Well Name: POKER LAKE UNIT 21 DTD	Well Location: T24S / R30E / SEC 16 / SESE / 32.211144 / -103.879676	County or Parish/State: EDDY / NM
Well Number: 158H	Type of Well: CONVENTIONAL GAS WELL	Allottee or Tribe Name:
Lease Number: NMLC0068430	Unit or CA Name: POKER LAKE UNIT	Unit or CA Number: NMNM71016X
US Well Number: 3001553257	Operator: XTO PERMIAN OPERATING LLC

Sundry ID: 2784173

Type of Action: APD Change

Procedure Description: XTO Permian Operating, LLC. respectfully requests approval to make the following changes to the approved APD. Changes to include SHL, FTP, LTP, BHL, Casing sizes, Cement, Proposed total Depth, and formation (Pool). FROM: TO: SHL: 237' FSL & 647' FEL OF SECTION 16-T24S-R30E 332' FSL & 157' FEL OF SECTION 16-T24S-R30E FTP: 386' FNL & 421' FEL OF SECTION 21-T24S-R30E 100' FNL & 935' FEL OF SECTION 21-T24S-R30E LTP: 329' FNL & 316' FEL OF SECTION 33-T23S-R30E 2538' FNL & 931' FEL OF SECTION 33-T24S-R30E BHL: 200' FNL & 315' FEL OF SECTION 33-T23S-R30E 2628' FNL & 932' FEL OF SECTION 33-T24S-R30E The proposed total depth is changing from 33752' MD; 12012' TVD (Wolfcamp) to 23956' MD; 11060' TVD (Wolfcamp X/Y). See attached Drilling Plan for updated cement

WELL LOCATION AND ACREAGE DEDICATION PLAT

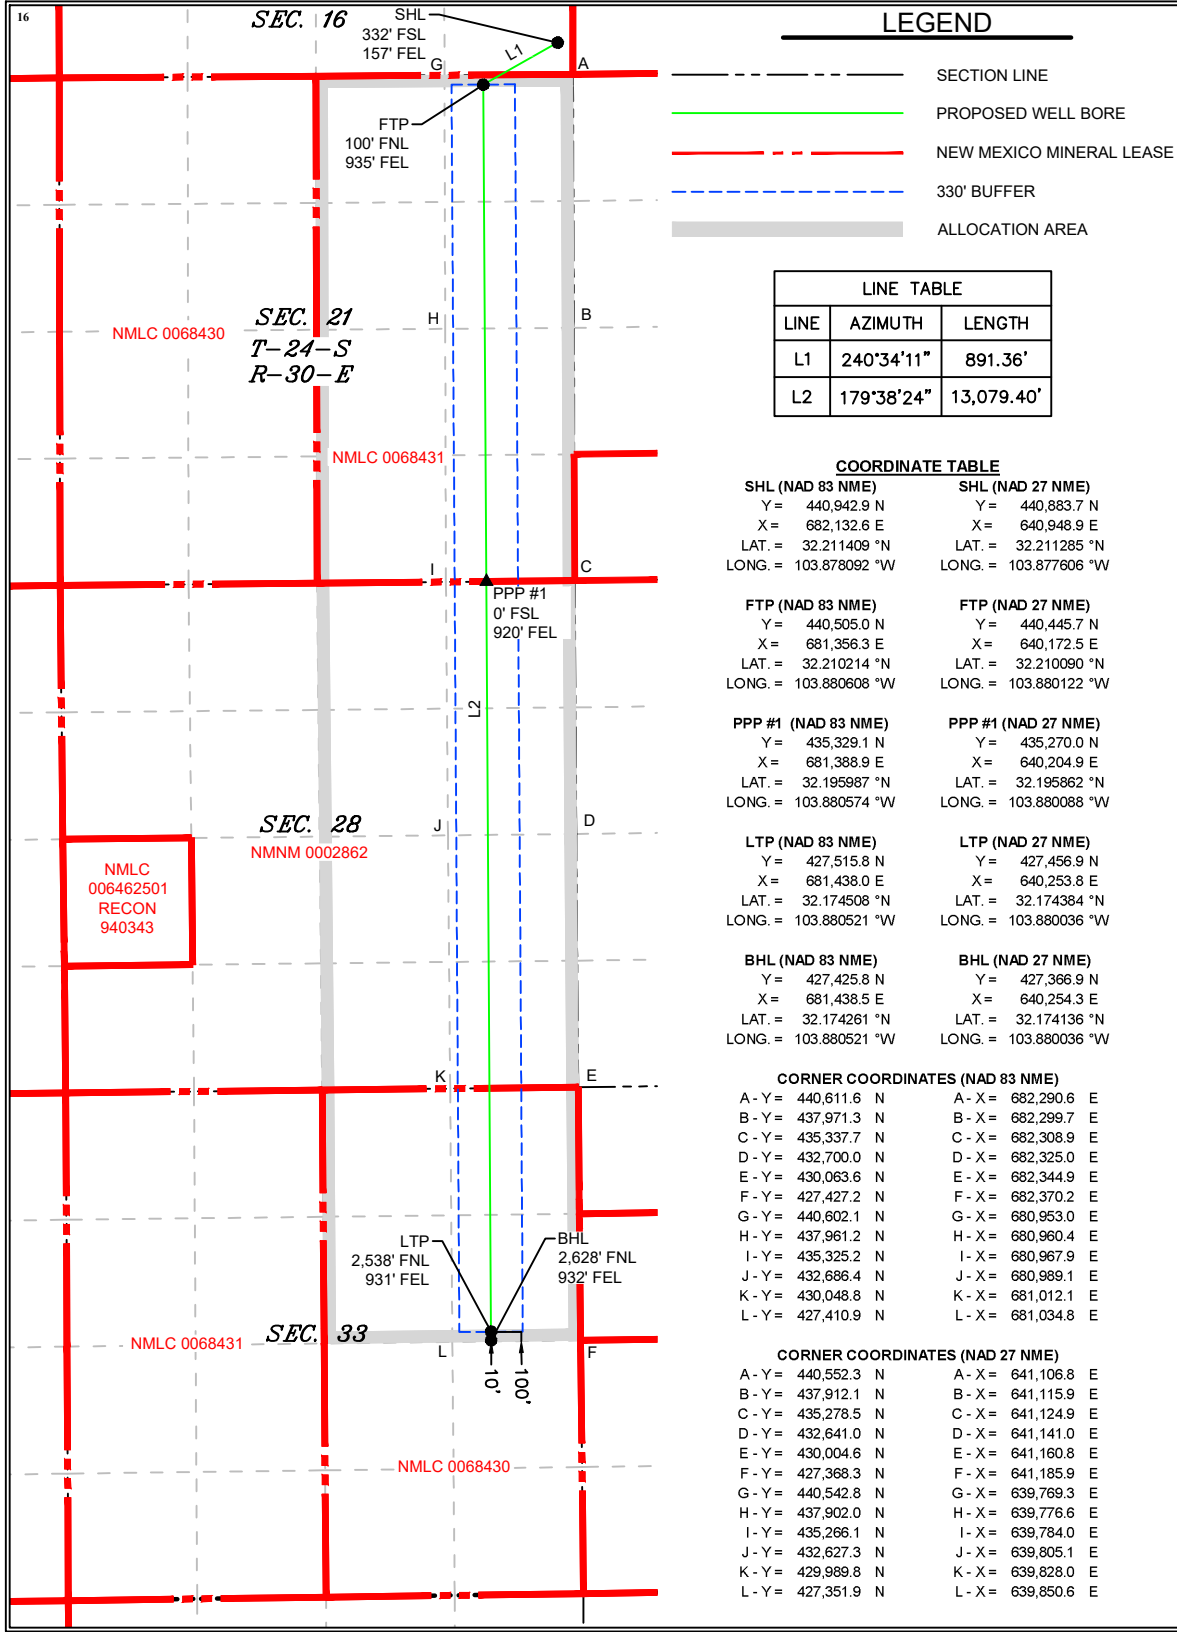
0. SHL: SESE / 237 FSL / 647 FEL / TWSP: 24S / RANGE: 30E / SECTION: 16 / LAT: 32.211144 / LONG: -103.879676 (TVD: 0 feet, MD: 0 feet)

PPP: NENE / 386 FNL / 421 FEL / TWSP: 24S / RANGE: 30E / SECTION: 21 / LAT: 32.209432 / LONG: -103.878949 (TVD: 12012 feet, MD: 12500 feet)

BHL: NENE / 200 FNL / 315 FEL / TWSP: 23S / RANGE: 30E / SECTION: 33 / LAT: 32.268076 / LONG: -103.878607 (TVD: 12012 feet, MD: 33752 feet)
